Technical Service Bulletin: tsb100418

Revised Fan Idler Assembly

This parts topic introduces a revised fan idler arrangement for the QSK45, QSK60 and QSK78 series engines. The revised design will improve fan hub reliability and durability.

08500775

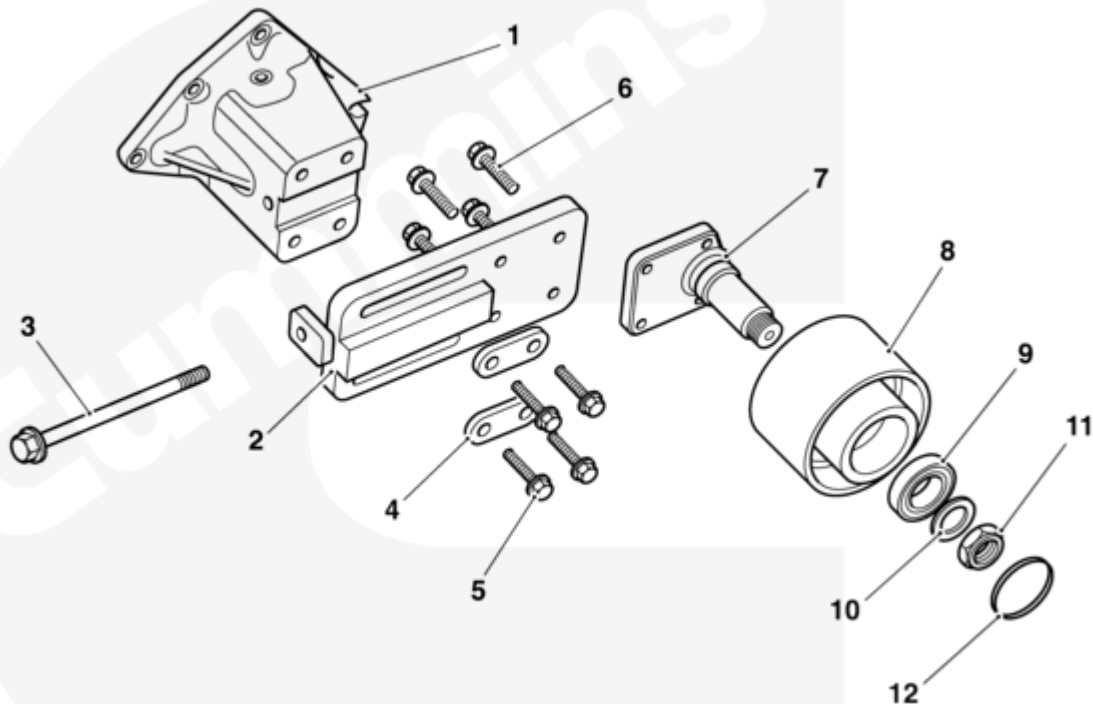
The revised fan idler went into production in August 2004 at the Daventry Engine plant. Engine serial number first was 33157417.
